**Pacific Gas and
Electric Company**

PG&E Letter DCL-01-115

Docket No. 50-275, OL-DPR-80
Docket No. 50-323, OL-DPR-82
Diablo Canyon Units 1 and 2
License Amendment Request 01-05

Revision to Technical Specification 1.1, "Definitions, Dose Equivalent I-131," and
Revised Steam Generator Tube Rupture and Main Steam Line Break Analyses

Figure 15.4.3-9 Ruptured SG Mass Release Rate to the Atmosphere

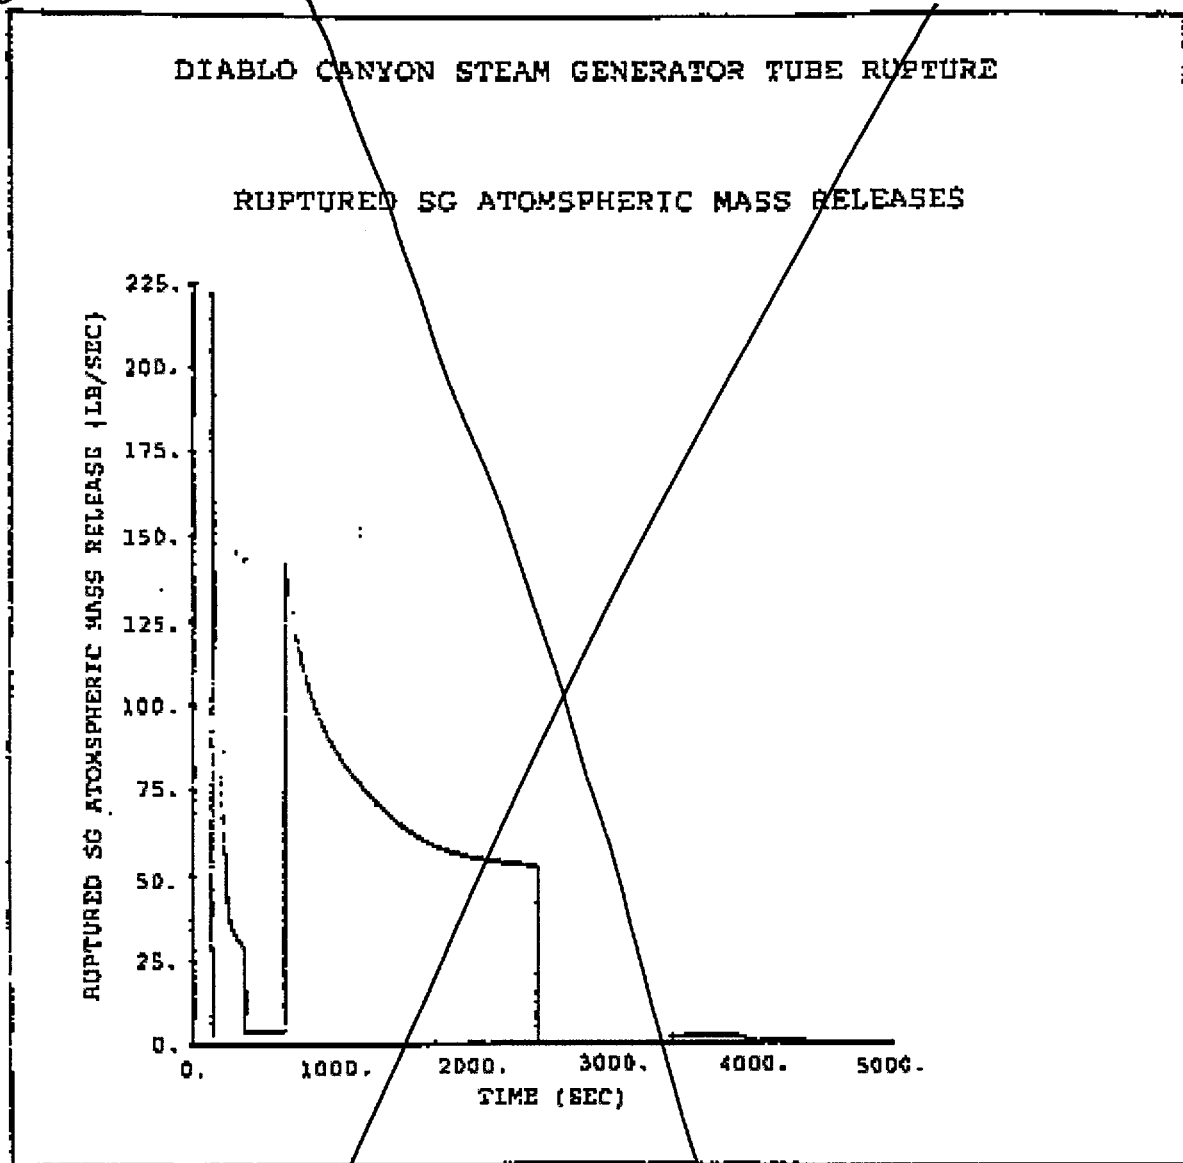
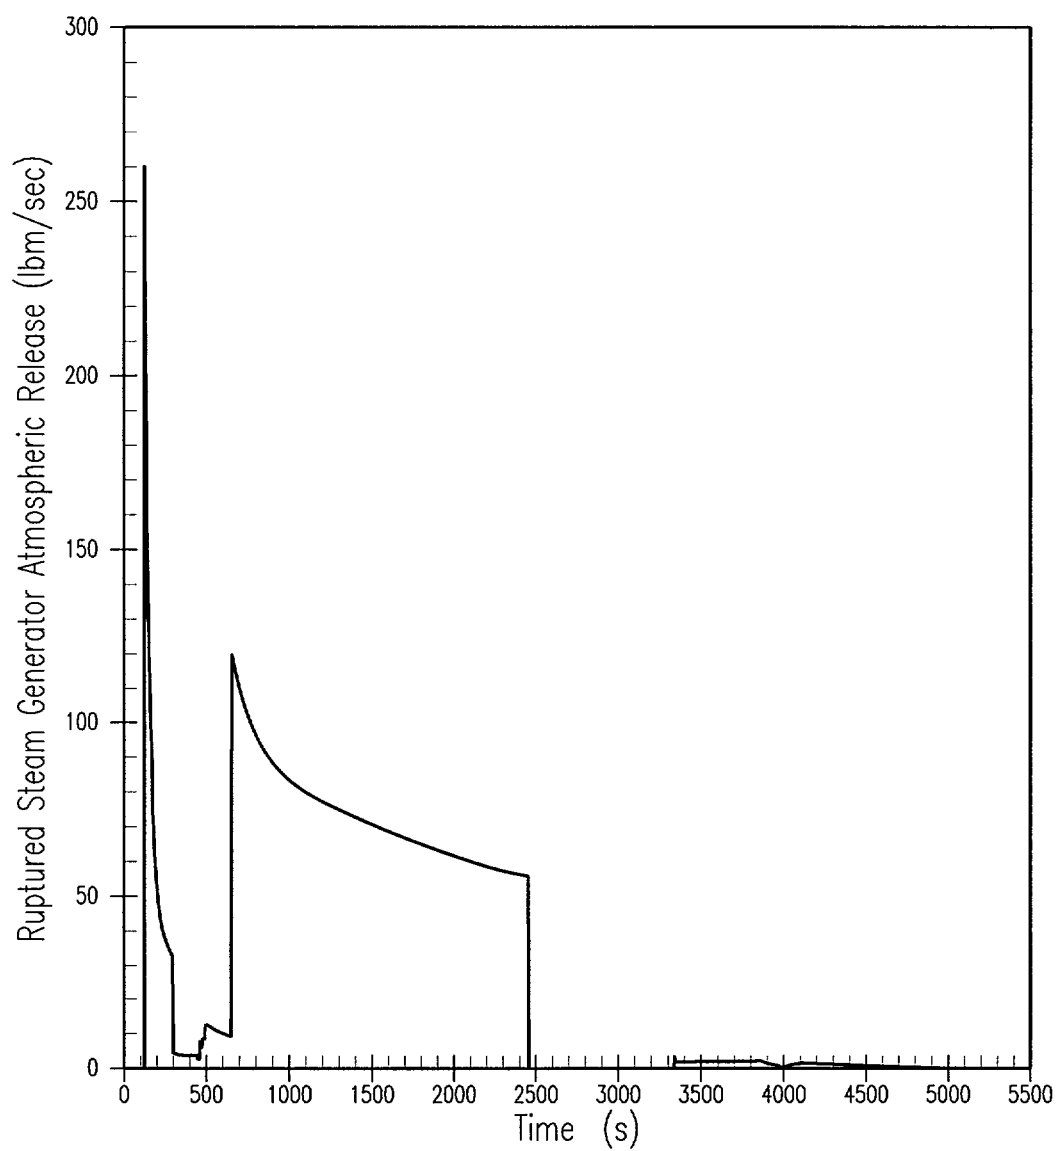
Replace with Figure 15.4.3-9

Figure 15.4.3-10 Intact SGs Mass Release Rate to the Atmosphere

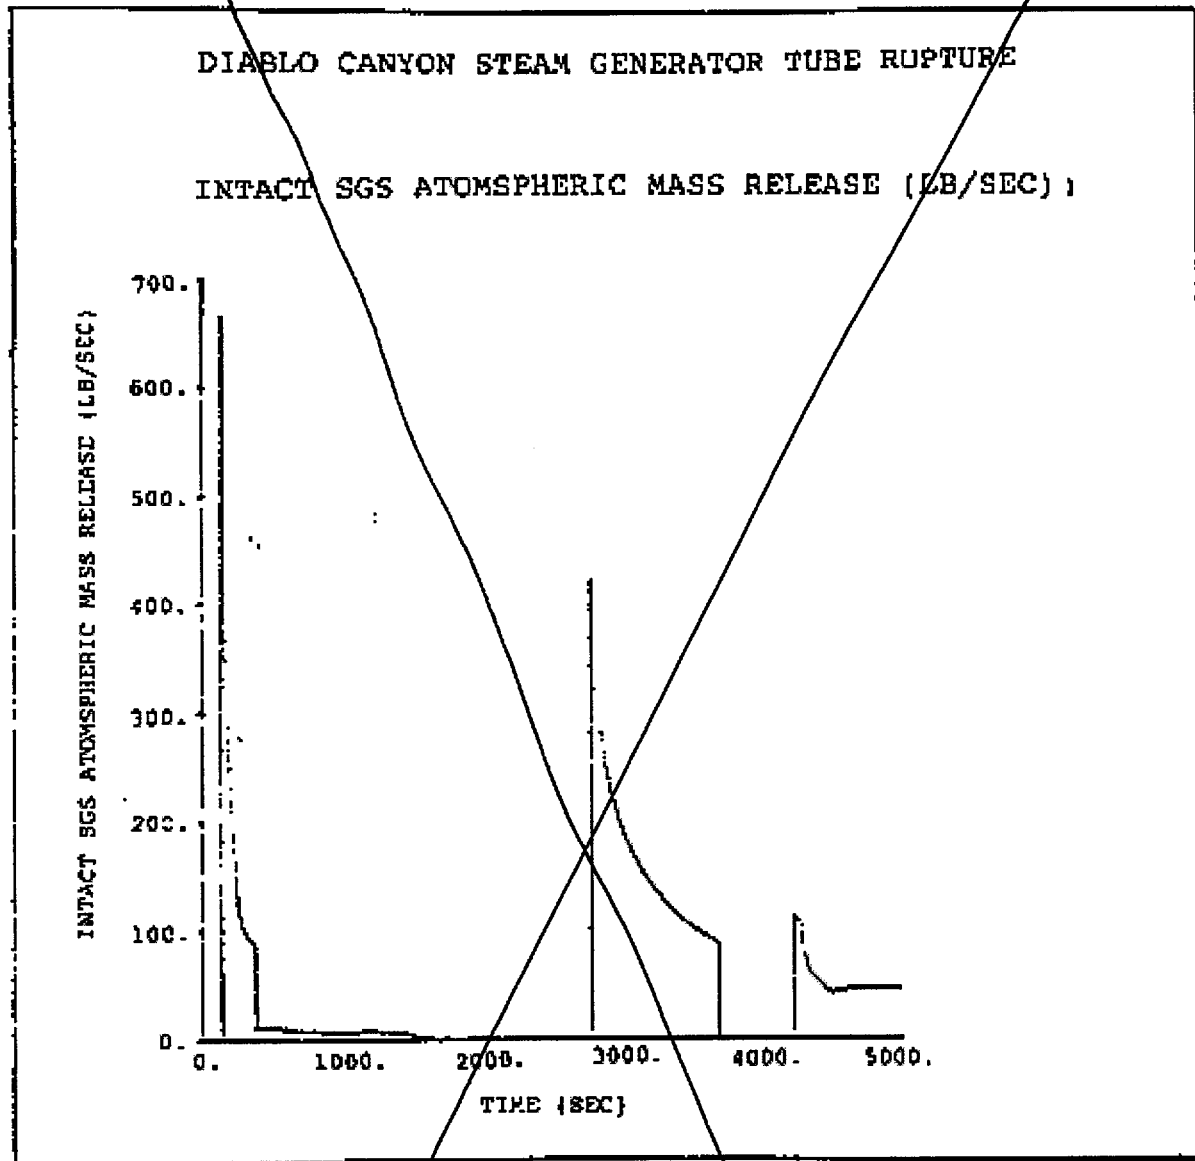
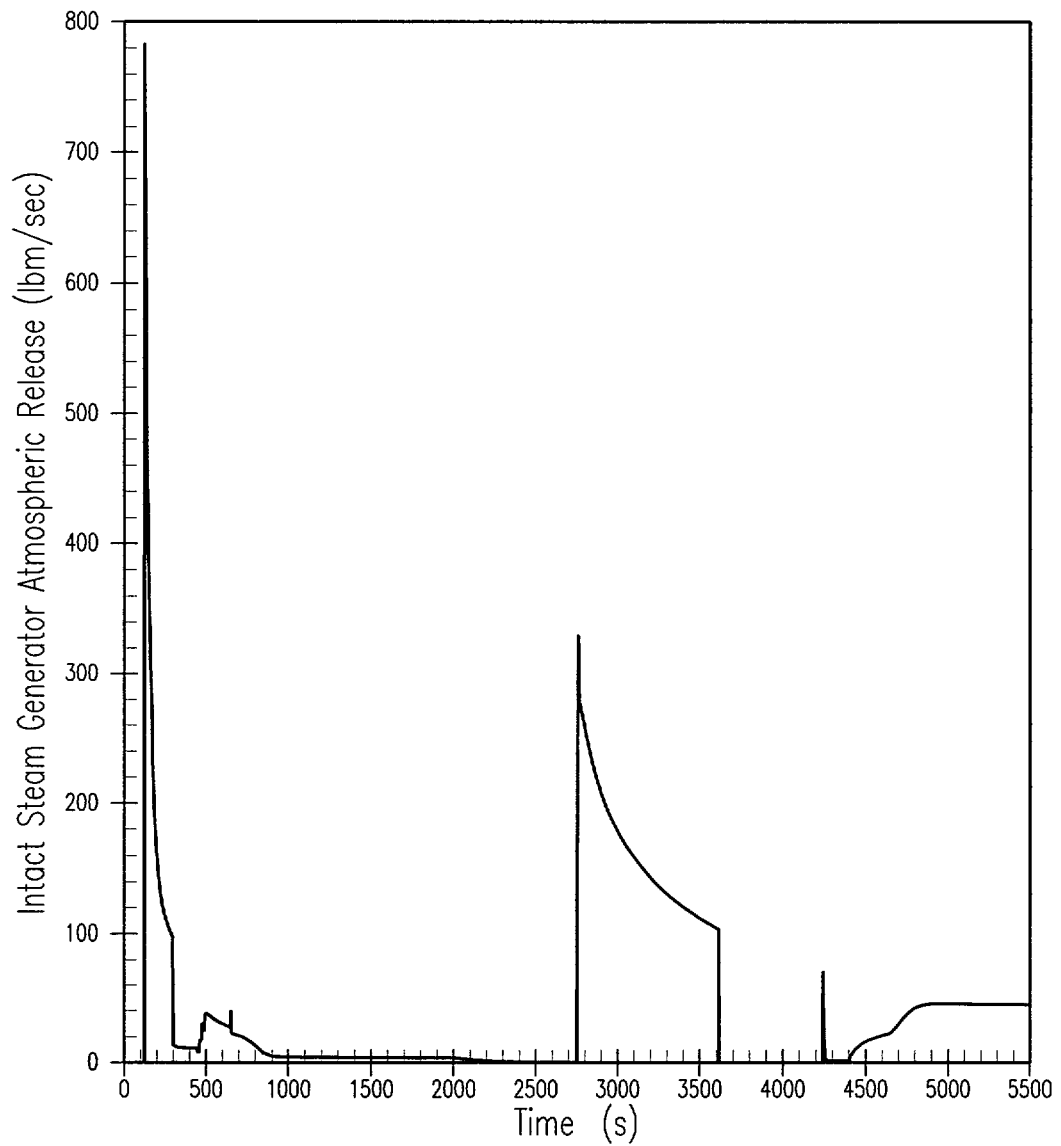
Replace with Figure 15.4.3-10

Figure 15.5-20 Break Flow Flashing Fraction - SGTR Analysis

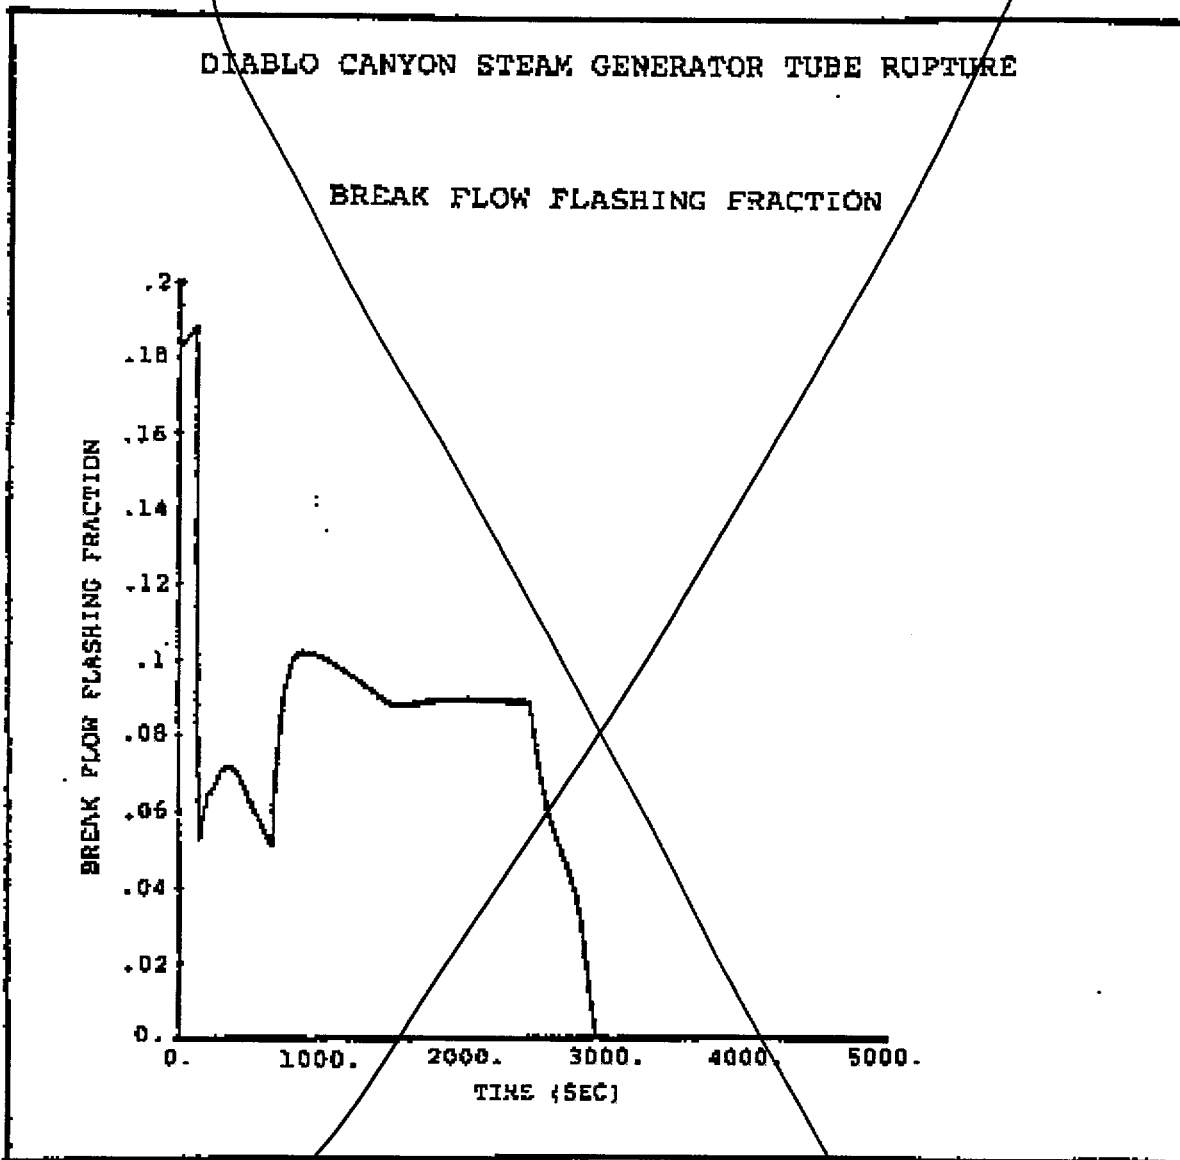
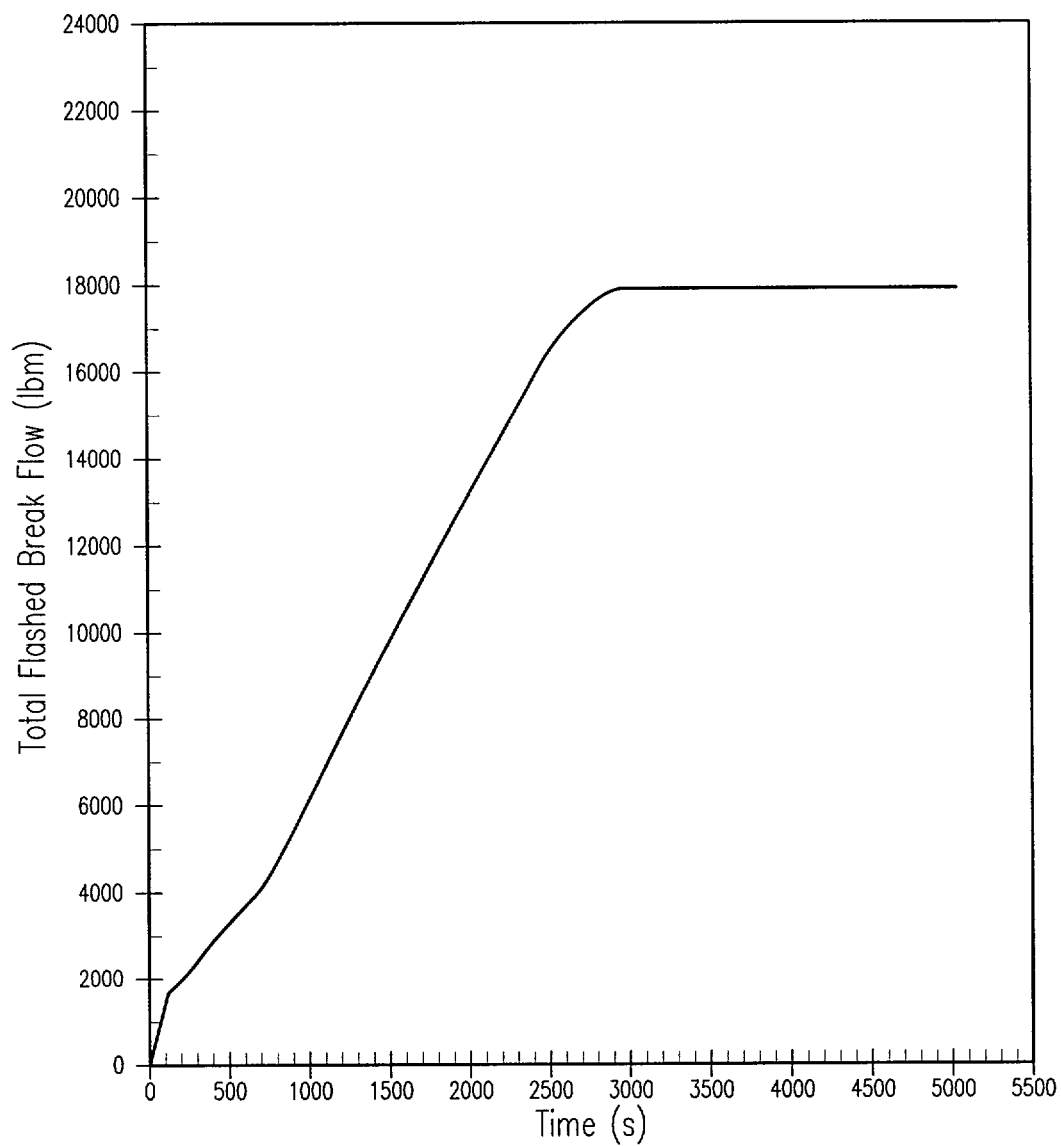
^ <i>Flashed</i> | See Figure 15.5-20 ^{15.4.3-11} and Table 15.4-14 | |

Figure 15.5-22 Iodine Scrubbing Efficiency - SGTR Analysis

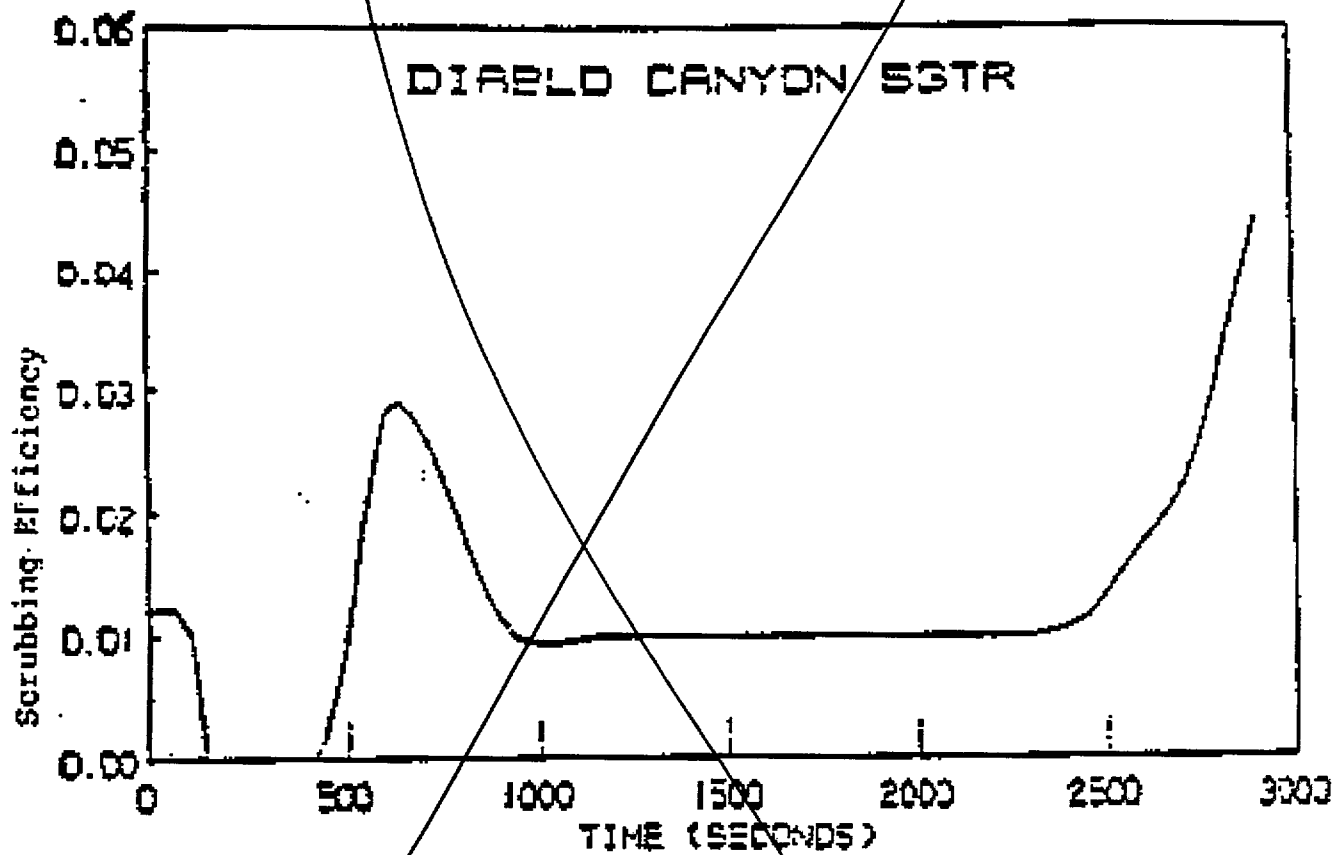
| 3. Iodine scrubbing efficiency | See Figure 15.5-22 ^{Not Modeled} | |
